NOTICE OF DENIAL

RE: Application Number 22-8057; 691 W. Canfield; West Canfield Historic District

CERTIFICATE OF APPROPRIATENESS

691 W Canfield SCOPE OF WORK

EAST ELEVATION
SECOND CHIMNEY
BACK

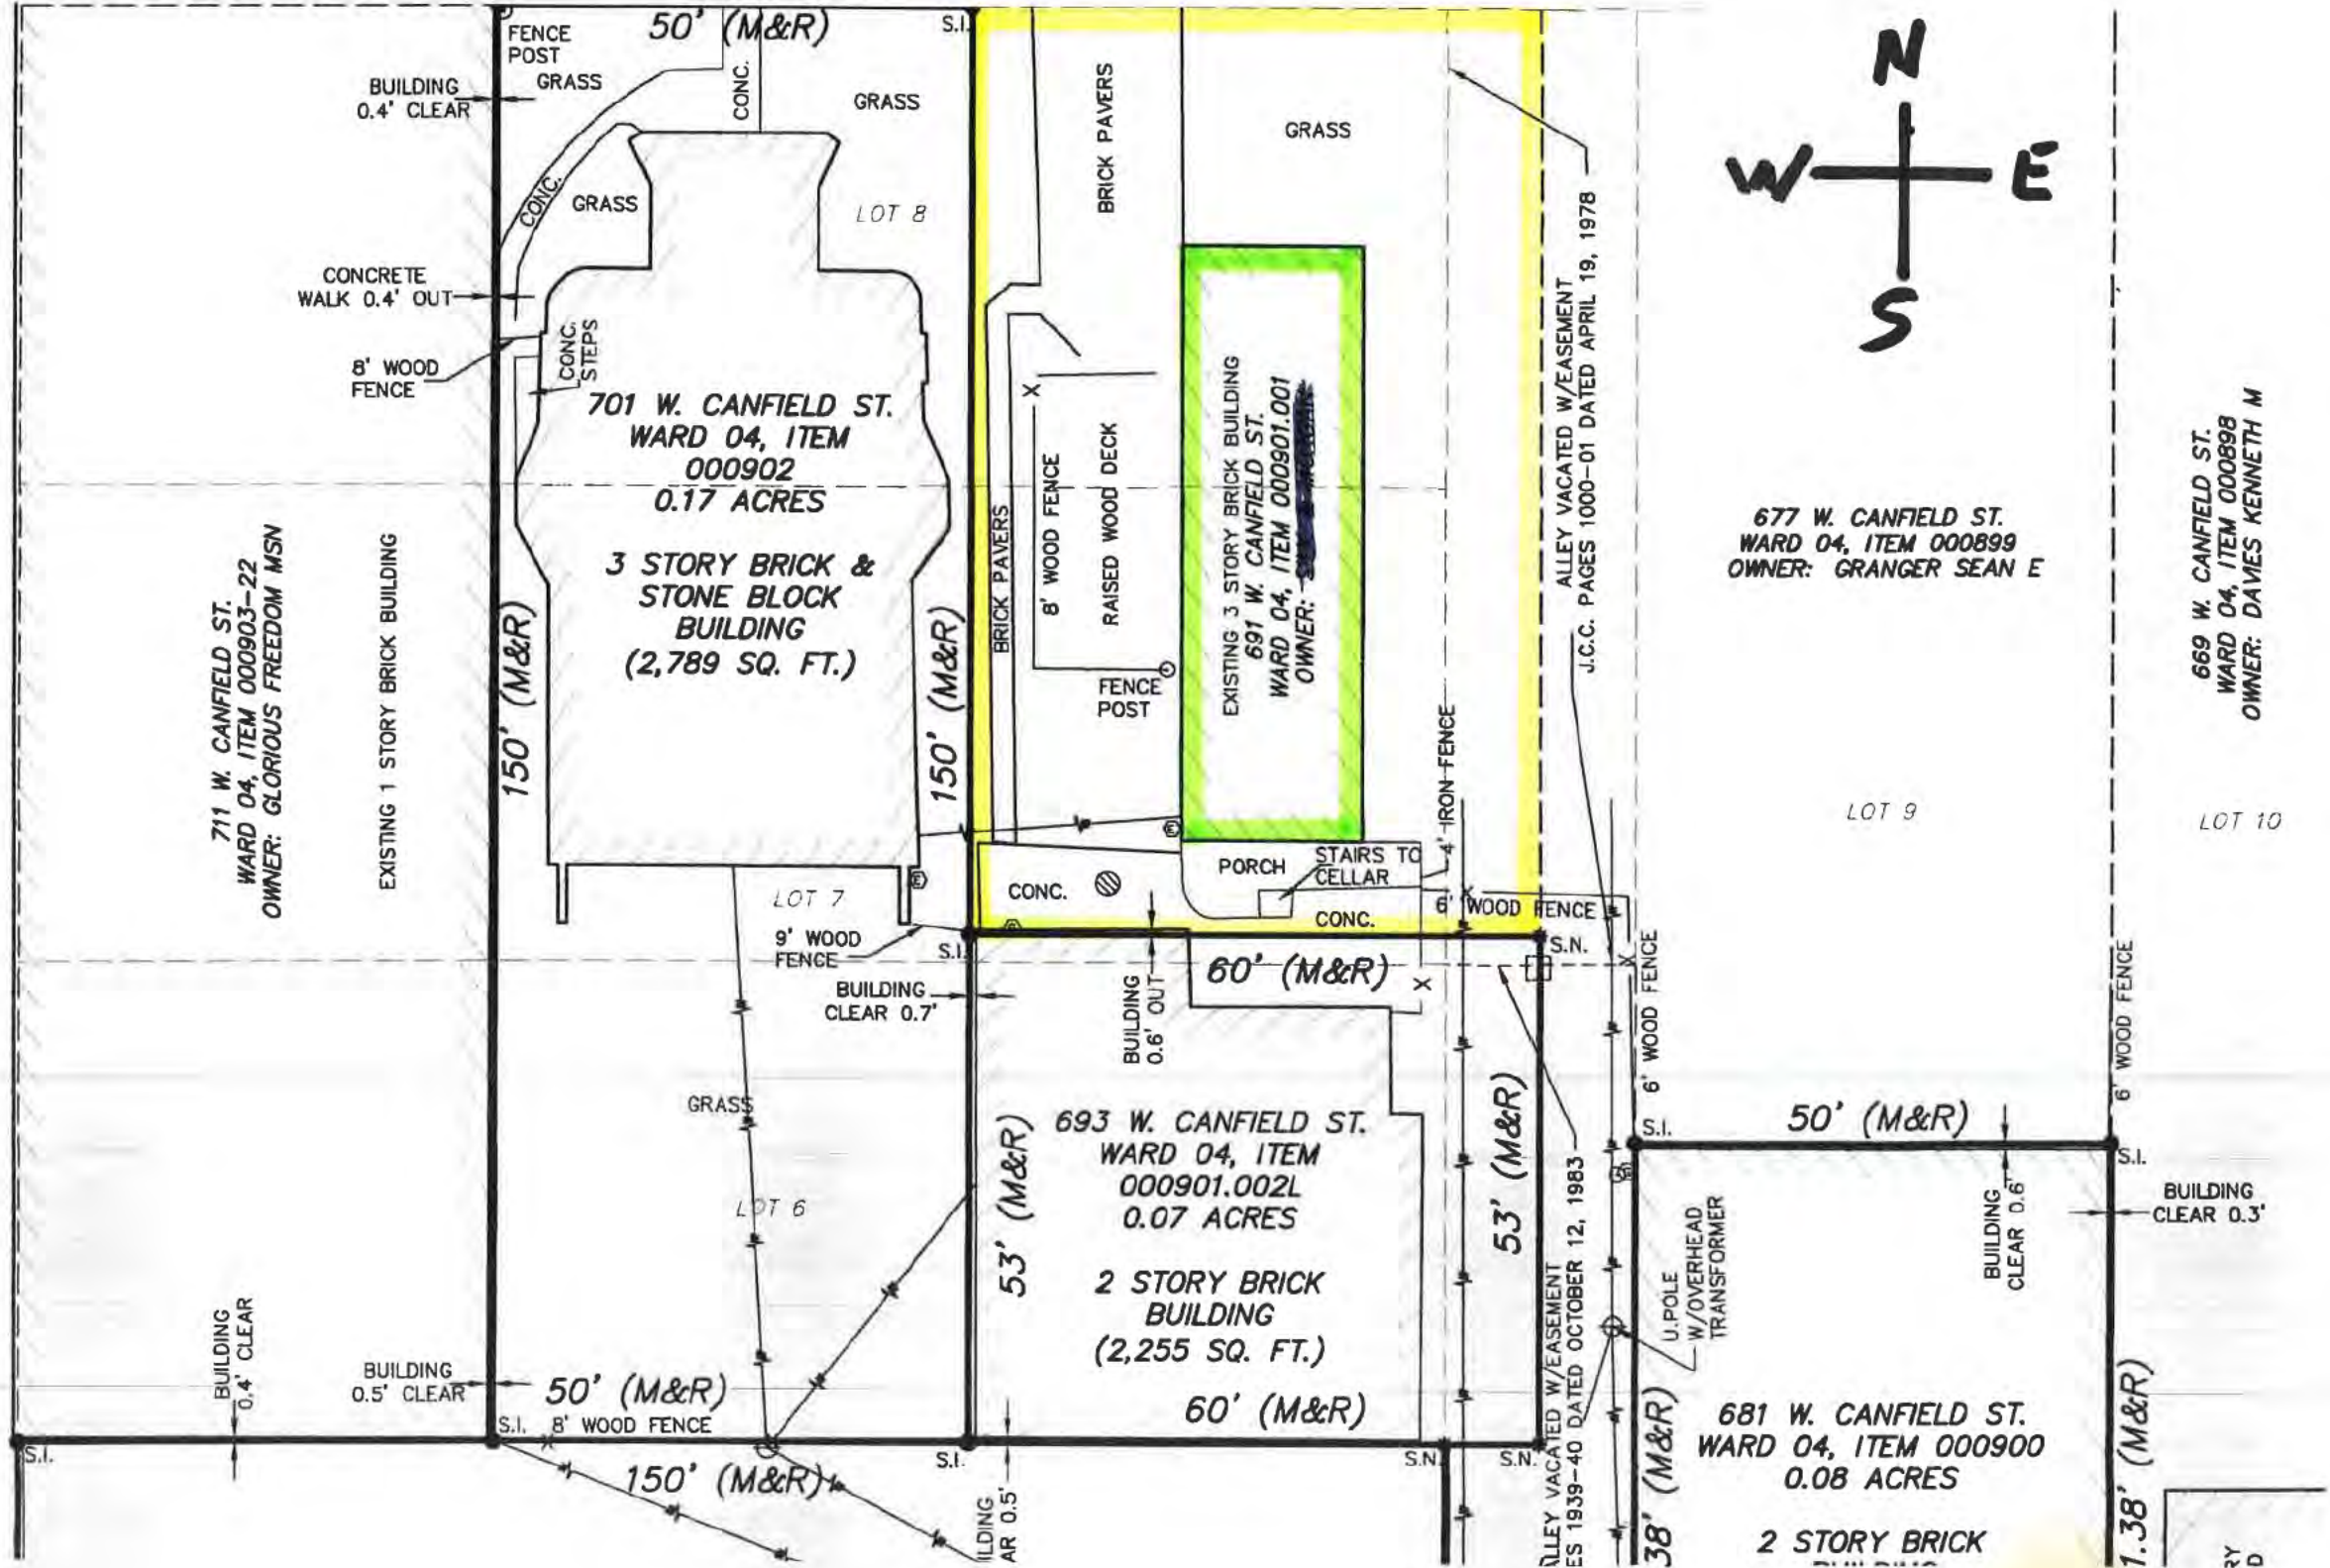
INVESTIGATE STRUCTURAL
INTEGRITY OF LEANING
CHIMNEY. DETERMINE IF
CHIMNEY HAS CRACKED
AND REMOVE BRICK
DOWN TO STONE COLLAR,
OR INTRODUCE CHIMNEY
BRACE.

EXISTING BRICK FROM
HOUSE TO BE REUSED
IF REQUIRED

691 W CANFIELD
SITE PLAN

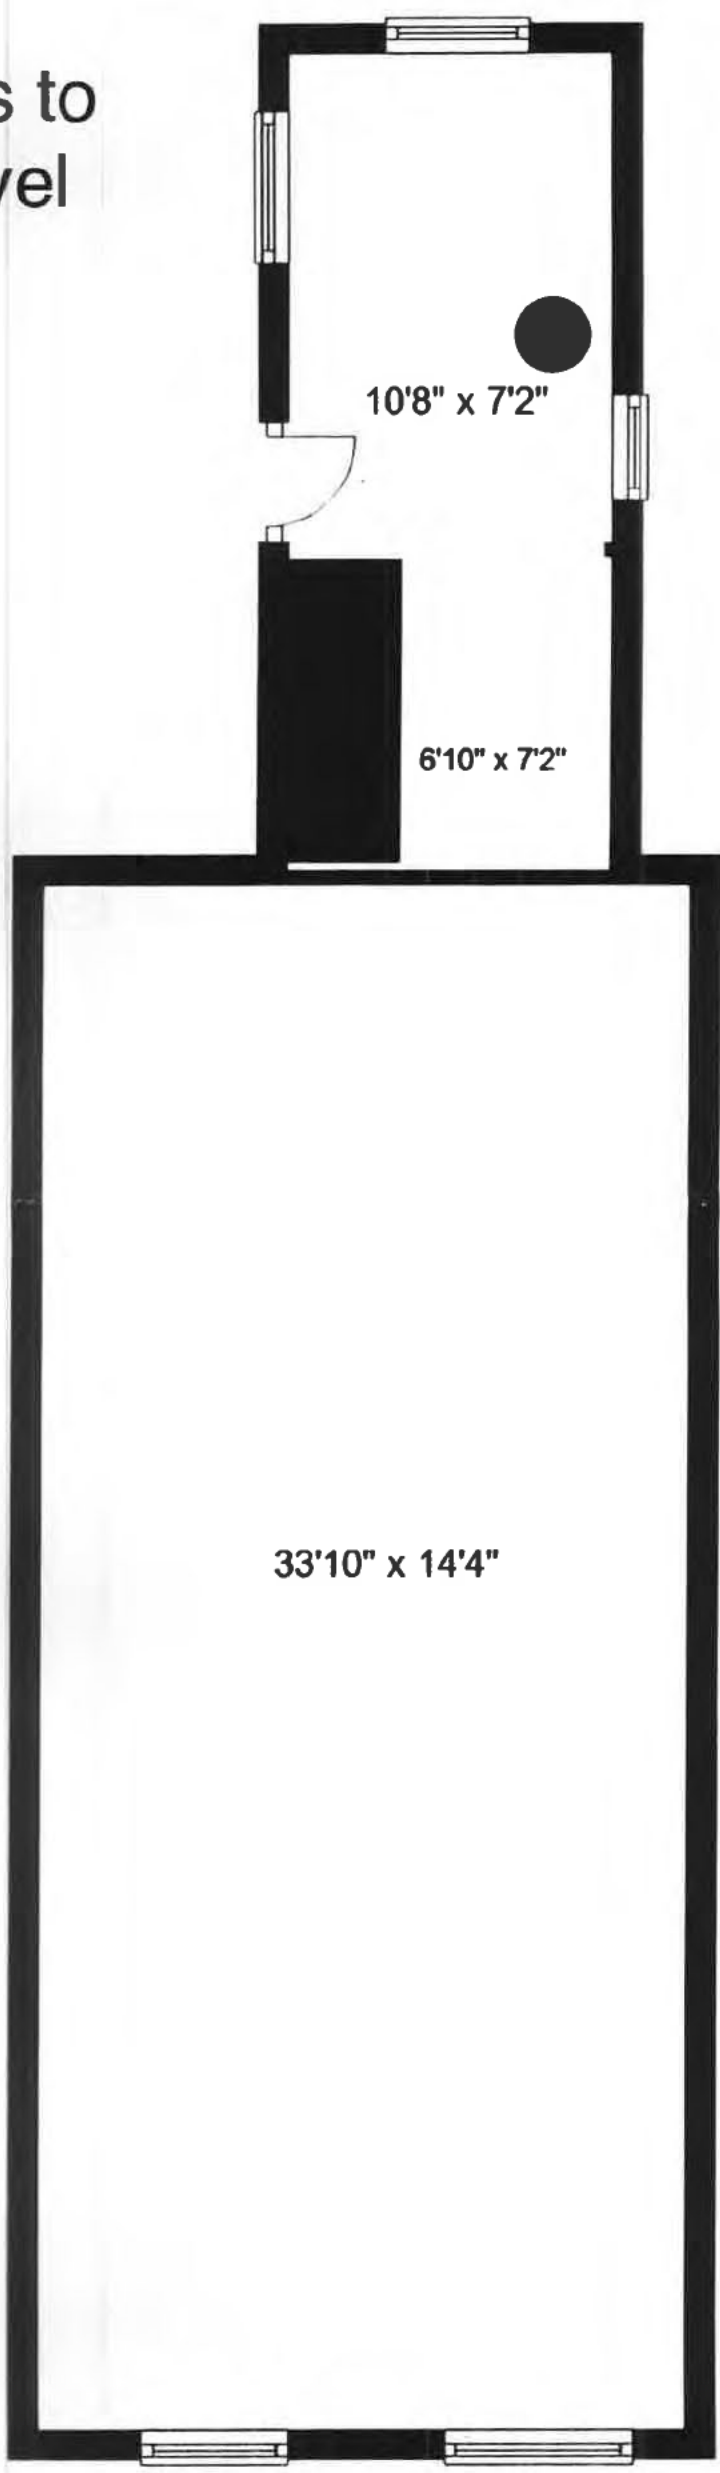
1. Thank you! This helps to clarify the plan greatly.
2. The key for your fence line (2 black colors) and the fence in the plan (black and blue lines) seem to indicate an overlap of fence types- and I don't see where the metal fence line is located. Can you help clarify the proposed fence installations and types?
YES TOO MANY LINES AND COLORS. ON THE WEST SIDE WE WERE LOOKING TO INTERSPERSE METAL AND WOOD FENCE. The point of that is that there are a number of windows near grade in the next door house that look directly onto the back patio so we were thinking to mix the fencing from the wood to the metal. I will try to draw something up that illustrates that specifically.

3. The pink areas are all for the new stone pavers (from Hart Plaza), correct? So the front yard will fill in areas at on either side of the driveway, correct?
YOU ARE CORRECT DAN HOWEVER WHEN I RETHINK IT, IT WOULD MAKE MORE SENSE TO USE THE HART PLAZA STONE ON THE BACK RIGHT SIDE PATIO AND USE THOSE BRICK PAVERS UP FRONT ON THE DRIVEWAY EXTENSION. All of the pavers need to come up and be re laid and I think the quantities would work. Then we could keep consistent with the brick pavers on the driveway, original walkway and slip over to the hart ones on the side path and the back patios.
What are your thoughts ?

691 W CANFIELD
SOUTH PARTIAL
ELEVATION

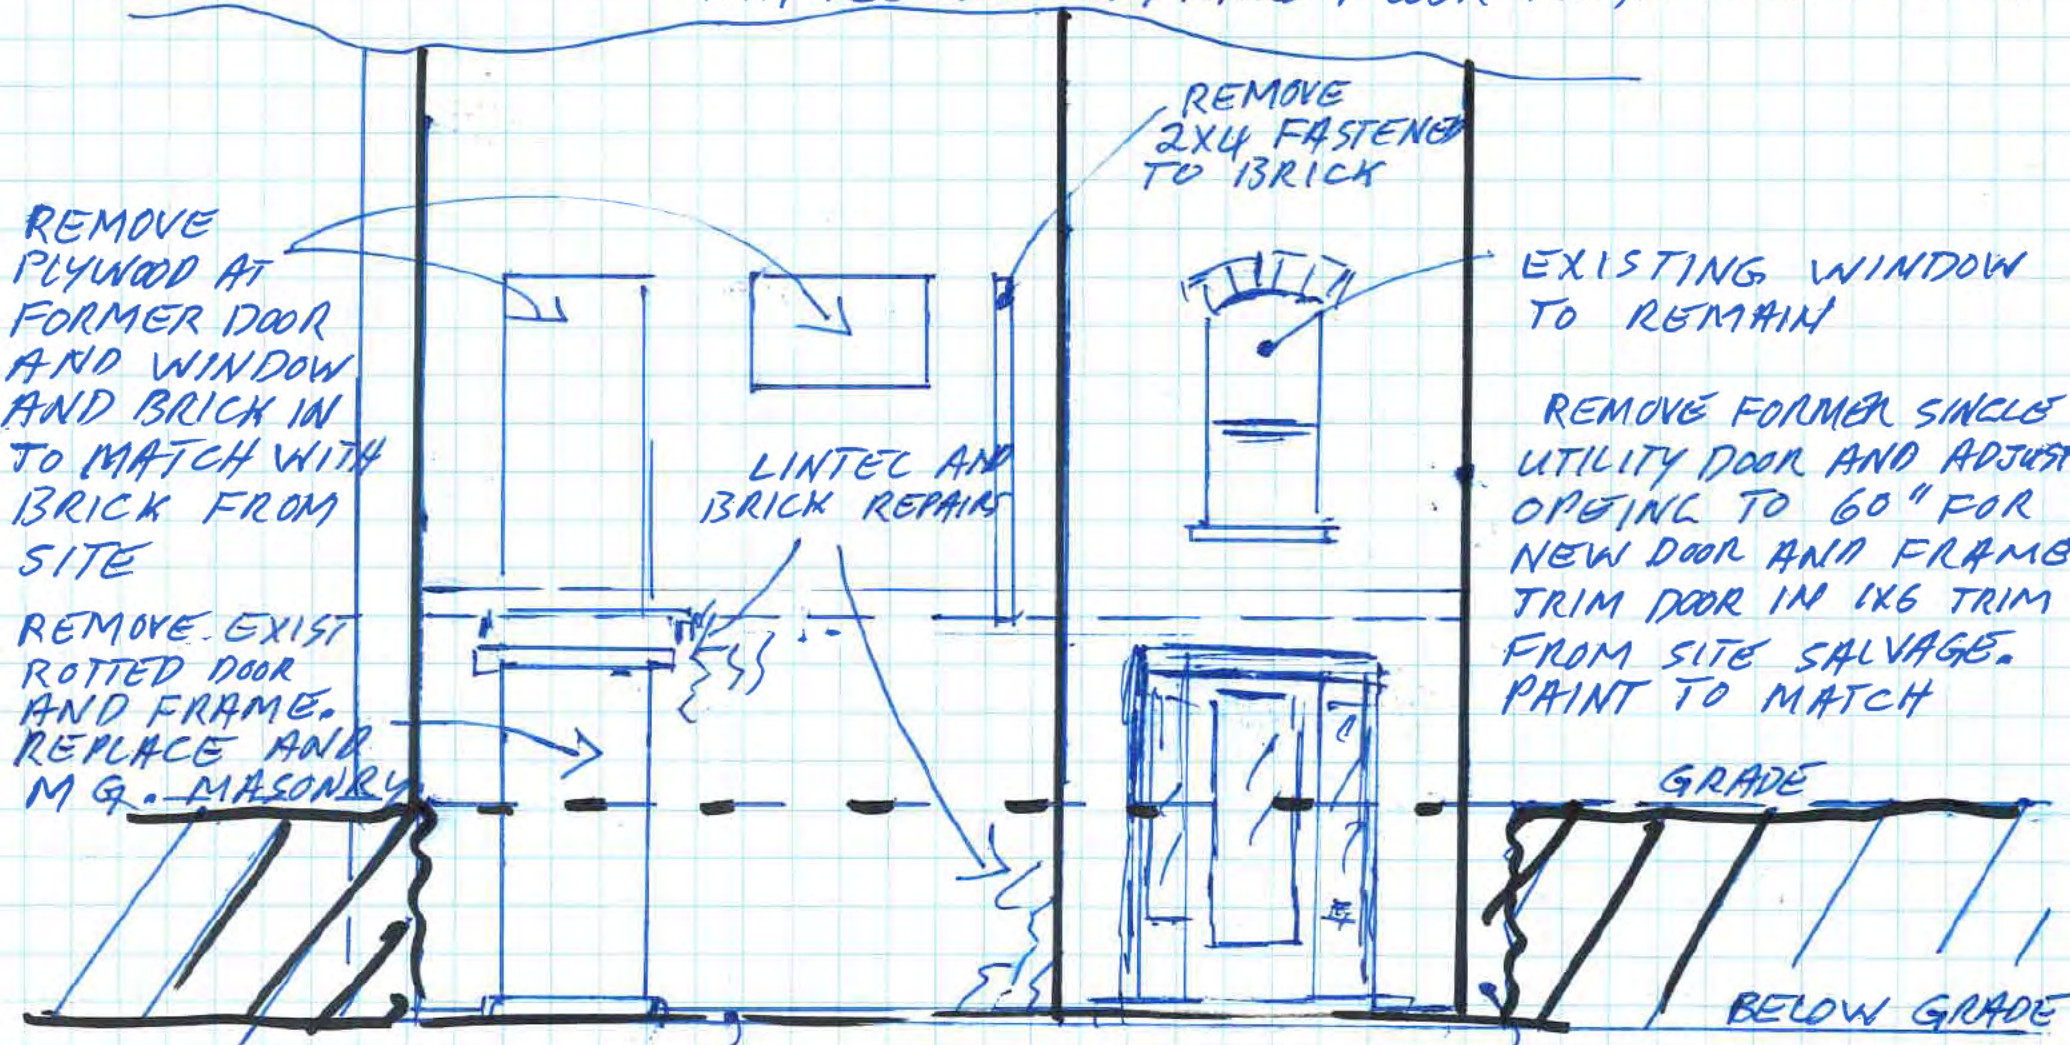
NO CHANGES SECOND/THIRD FLOOR REAR ELEVATIONS

GENERAL NOTE:
MAKE GOOD EXISTING
BROKEN / LOOSE / MISSING
BRICKS WITH BRICKS TO
MATCH

DOORS BASEMENT LEVEL

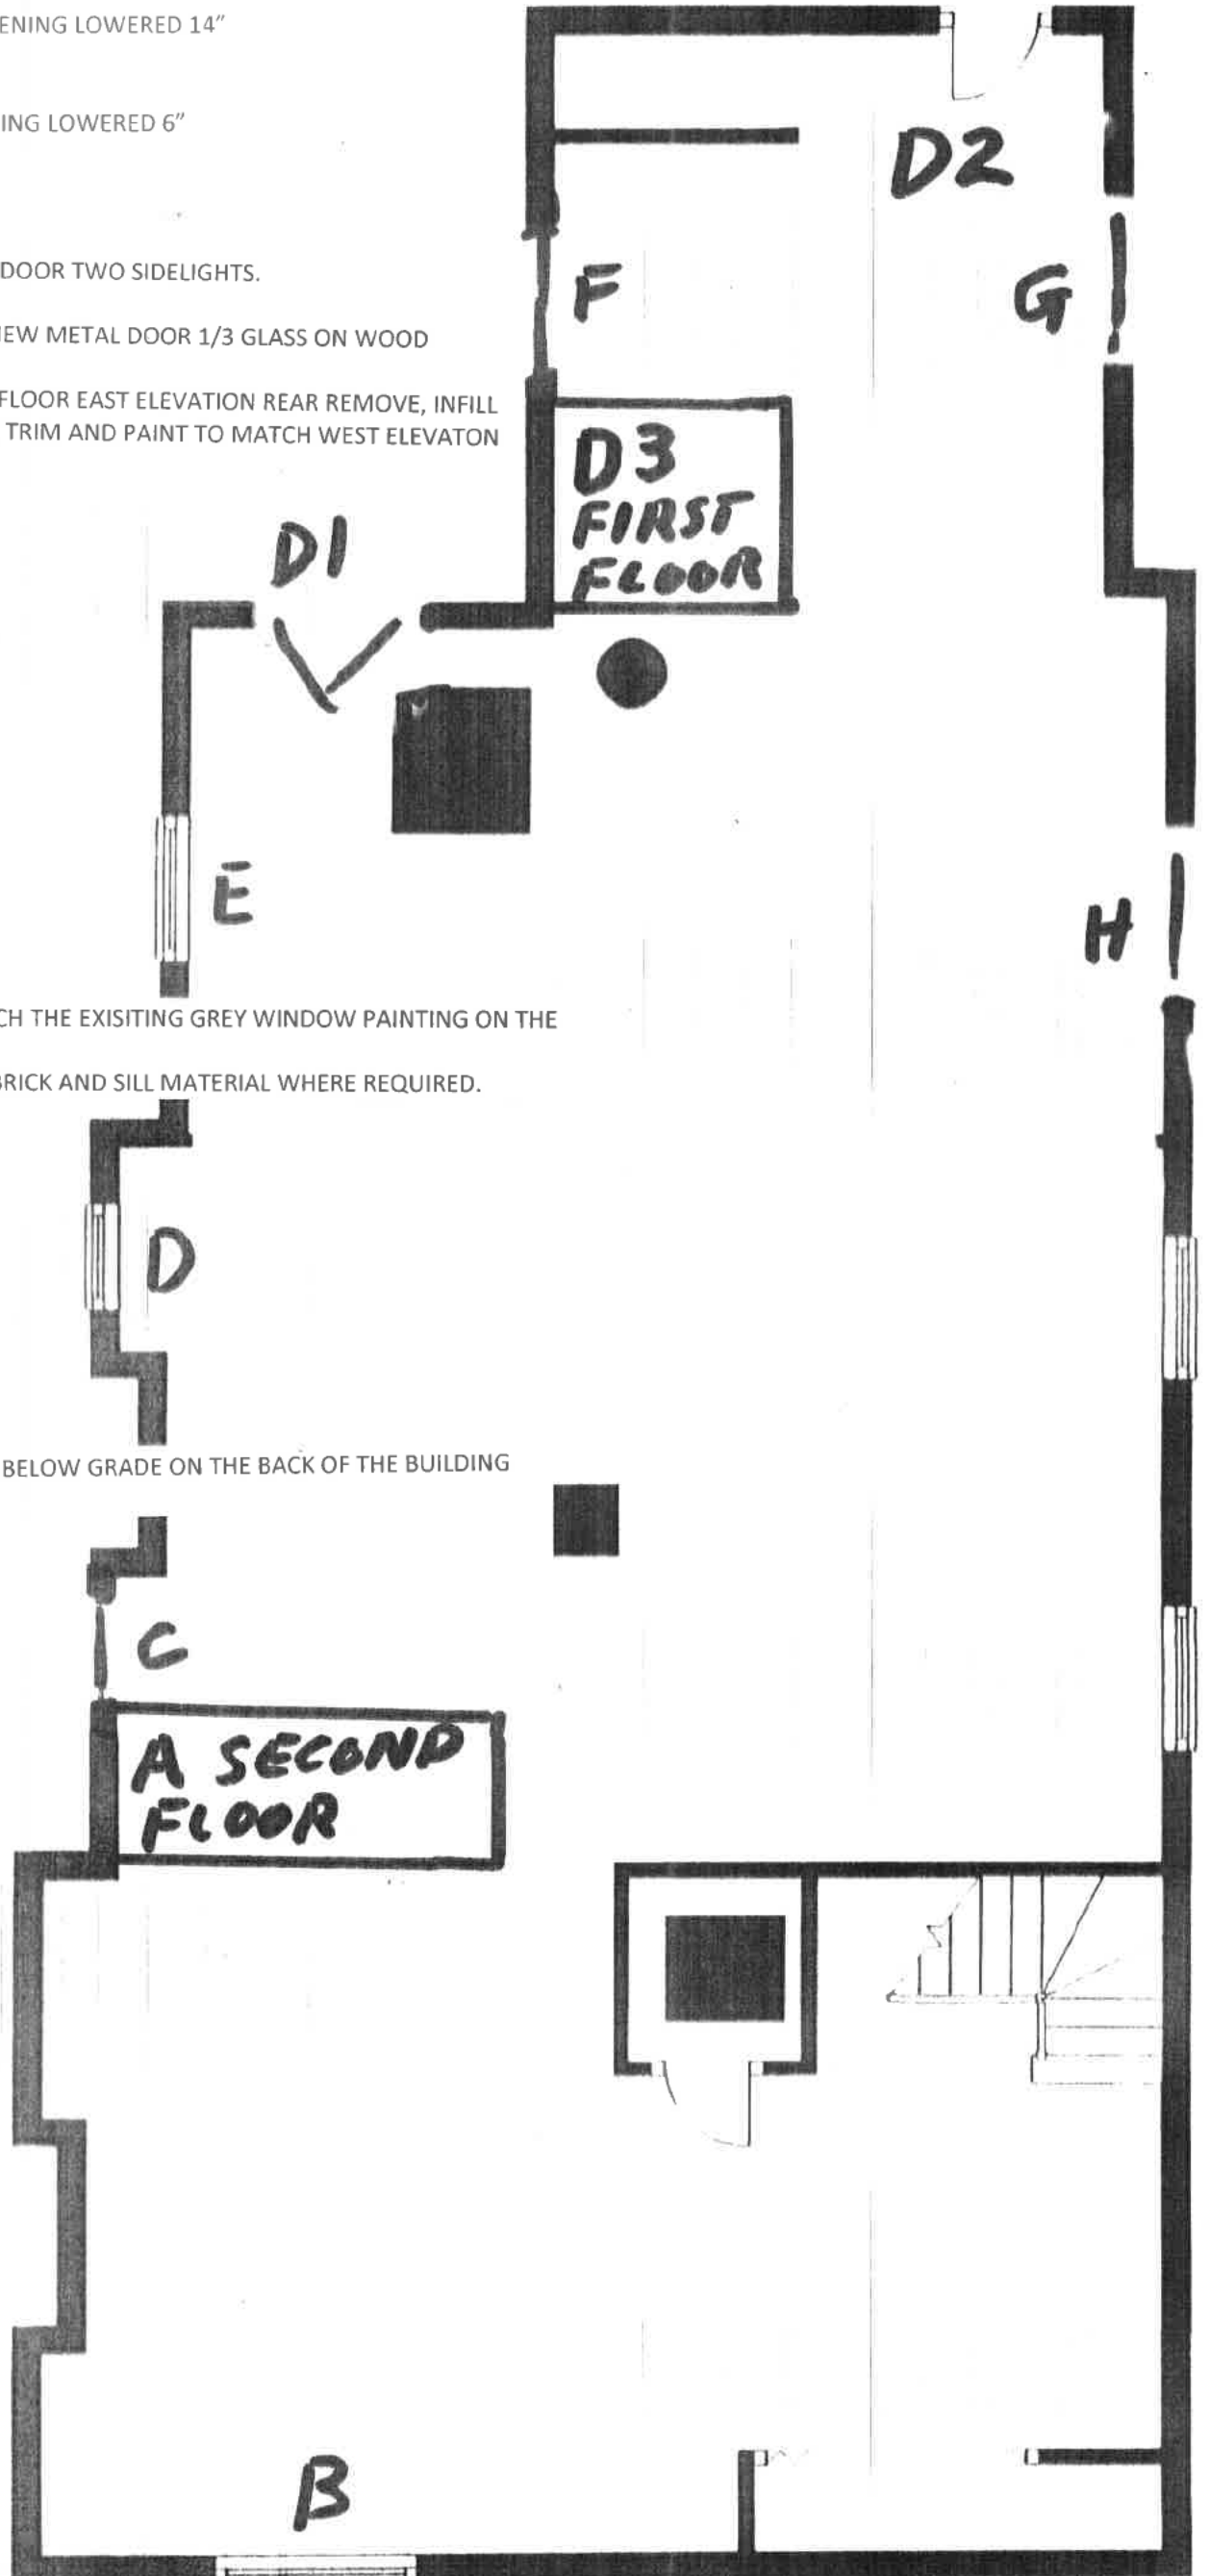
SECOND FLOOR - ONE WINDOW ADDED TO EXISTING OPENING. OPENING EXTENDED IN LENGTH
"A" EAST ELEVATION, VINYL, SINGLE HUNG, REPLACEMENT, PAINT TO MATCH

BASEMENT - ONE NEW WINDOW ADDED, 6 REPLACEMENT WINDOWS TOTAL 7
"B" NORTH ELEVATION, VINYL, SINGLE HUNG, REPLACEMENT OPENING LOWERED 10"
"C" EAST ELEVATION, VINYL, SINGLE HUNG, NEW OPENING
"D" EAST ELEVATION, VINYL, SINGLE HUNG, REPLACEMENT OPENING LOWERED 14"
"E/F" EAST ELEVATION, VINYL, AWNING, REPLACEMENT
"G" WEST ELEVATION, VINYL, AWNING, REPLACEMENT
"H" WEST ELEVATION, VINYL, CASEMENT, REPLACEMENT, OPENING LOWERED 6"

"D1" EXISTING UTILITY REMOVED AND REPLACED WITH GLAZED DOOR TWO SIDELIGHTS.
OPENING WIDENED TO SUIT. LINTEL INSERTED TO CARRY BRICK
"D2" EXISTING UTILITY DOOR REMOVED AND REPLACED WITH NEW METAL DOOR 1/3 GLASS ON WOOD
FRAME. REBUILD FAULTED SILL AND LINTEL
"D3" EXISTING NON ORIGINAL ROTTED GLASS DOORS ON FIRST FLOOR EAST ELEVATION REAR REMOVE, INFILL
WITH FISH SCALE CEDAR SHINGLES TYPICAL TO WEST ELEVATION, TRIM AND PAINT TO MATCH WEST ELEVATION
SHINGLES. STAINGLASS TRANSOM WINDOW OVER TOP.
